Contract #: 04-0120F4  
 Cty: SF/ALA Rte: 80 PM: 13.2/13.9  
 File #: 69.25B

## QUALITY ASSURANCE -- NON-CONFORMANCE REPORT

**Report No:** NCR-000693

<b>Welding</b>	<b>Concrete</b>	<b>Other</b>	
<b>Welding</b>	<b>Curing</b>	<b>Procedural</b>	<b>Bridge No:</b> 34-0006
<b>Joint fit-up</b>	<b>Coating</b>	<b>Other</b>	<b>Component:</b> Tower Strut ED1-A6001-4
<b>Procedural</b>	<b>Procedural</b>	<b>Description:</b>

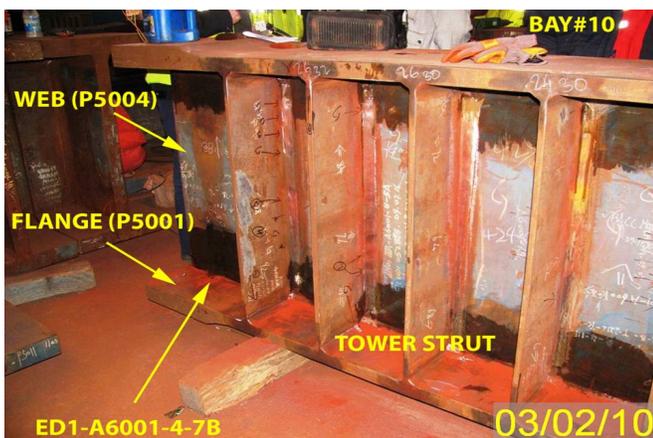
During random 10% verification Ultrasonic Testing (UT) of Tower Strut ED1-A6001-4, Caltrans (CT) Quality Assurance (QA) discovered one (1) Class "A" non-conforming longitudinal indication measuring approximately 15 mm in length.

- The weld is a complete joint penetration (CJP) joint, joining Web P5004 to Flange P5001 and is identified as ED1-A6001-4-7B.
- The discontinuity rating is +6, Class "A" reject.
- Depth of the discontinuity from face A is approximately 27 mm, and Y location was 130 mm.
- The material thickness is 32 mm.
- This member is located in fabrication Bay 10.
- The indication is in an area previously tested and accepted by ZPMC QC UT technicians.
- The Notice of Witness Inspection Number (NWIT) is 005259.

**Component:** Tower Strut ED1-A6001-4

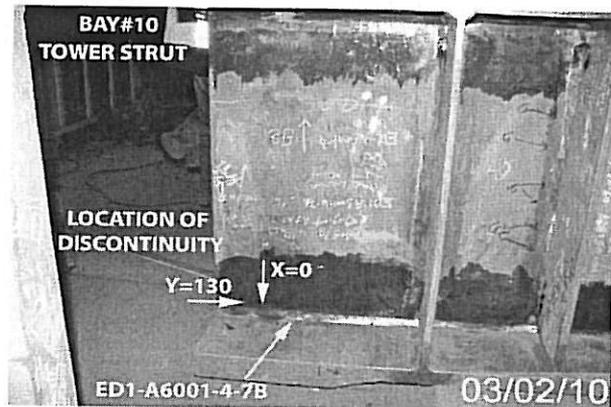
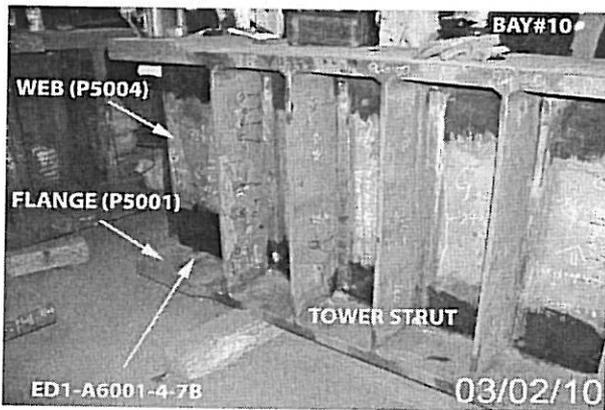
During random 10% verification Ultrasonic Testing (UT) of Tower Strut ED1-A6001-4, Caltrans (CT) Quality Assurance (QA) discovered one (1) Class "A" non-conforming longitudinal indication measuring approximately 15 mm in length.

- The weld is a complete joint penetration (CJP) joint, joining Web P5004 to Flange P5001 and is identified as ED1-A6001-4-7B.
- The discontinuity rating is +6, Class "A" reject.
- Depth of the discontinuity from face A is approximately 27 mm, and Y location was 130 mm.
- The material thickness is 32 mm.
- This member is located in fabrication Bay 10.
- The indication is in an area previously tested and accepted by ZPMC QC UT technicians.
- The Notice of Witness Inspection Number (NWIT) is 005259.

WELD NUMBER: ED1-A6001-4-7A/B

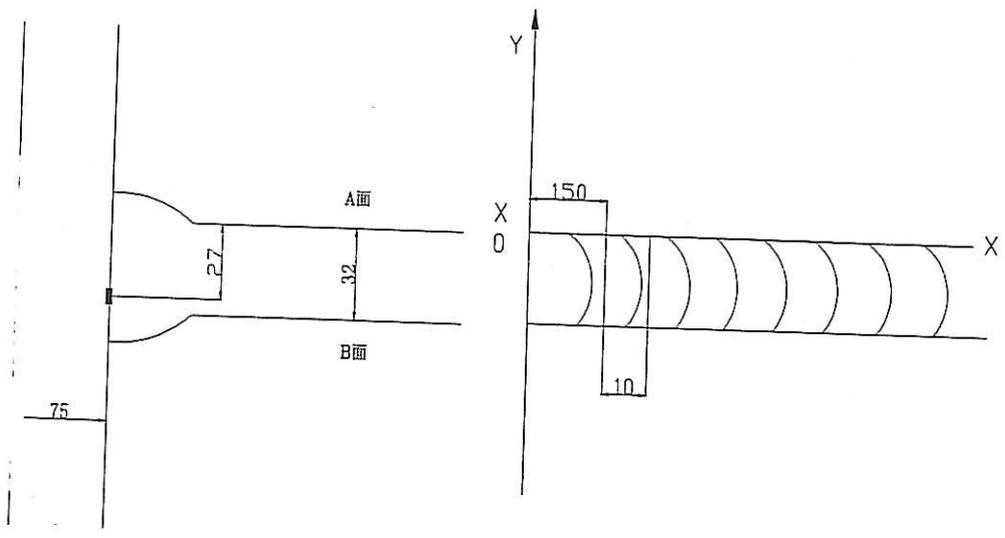
Rejected indication found by ultrasonic inspection is less than the maximum allowance aggregate length.

- 1、 碳刨后,焊接接头没有有效打磨;
  - 2、 起弧和收弧没有交错布置,以将焊渣减少到最少;
  - 3、 焊道间没有有效的清理.
- 1.The weld joint was not ground sufficiently after arc-gouging.
  2. The arc starts and stops were not staggered to minimize slag entrapment.
  3. Interpass cleaning was not performed properly.

1. Grind repair area smoothly, VT to verify repair area is free of all defects.
2. QC will monitor and direct welder and grinder doing repair;
3. QC shall monitor all welding passes being deposited;
4. QC shall ensure all slag has been removed prior the deposition of next pass;
5. Preheat and maintain interpass temperature control in accordance with the WPS ;
6. Perform VT, MT and UT accordance with the drawing & contract requirements
